TECHNICAL SERVICE BULLETIN

Victory Motorcycle Bulletin Number: **V-03-04(A)**

SUBJECT: FUEL TANK VENT OBSTRUCTED (U.S. 49 STATE, CANADA, and UK MODELS)

Attach a pressure pump

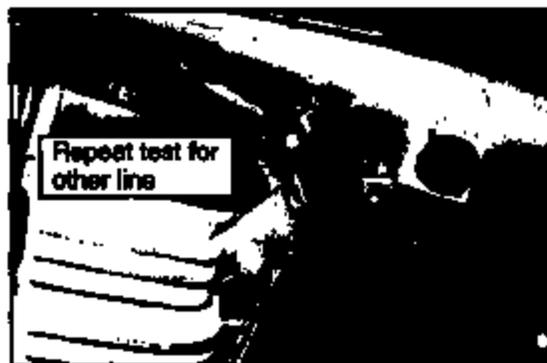
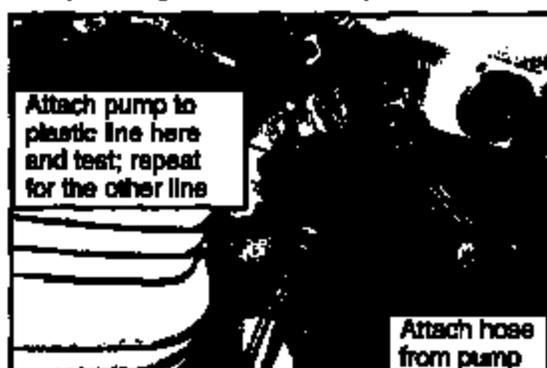
4. Attach a hand pump (i.e. a Mity Vac PV-43646) to the hard line on the fuel tank side as shown using an appropriate adaptor that seals tightly on the line.

5. Pump air into the line. Air should be heard escaping from the fuel cap area. If the pump does not build pressure (indicating a clear vent) but you do not hear air escaping from the filler neck or from the water drain hole, check to be sure the hose is connected to the fitting on the bottom of the fuel tank.
6. To determine which line you have, place your finger over the water drain opening which is located to the left of the gas cap opening. If the airflow stops you have located the water drain line. If the airflow continues, you have located the tank vent line and it is open. You should be able to hear the air escaping out the fuel tank filler neck.

7. If both lines are clear, reconnect them, close and lock the fuel cap, and reinstall the side cover. File a warranty claim for inspection only, and use V-03-04 as the bulletin number.
8. If you can not move air through the vent line (pressure builds on the gauge), the tank vent fitting is plugged, and you must replace the fuel cap and ignition switch assembly, following procedures outlined on page 5.3 & page 17.10 of the Victory Vegas Service Manual PN 9918371. File a warranty claim for inspection, cap, and switch replacement using bulletin number V-03-04A. The new fuel cap is a vented type.
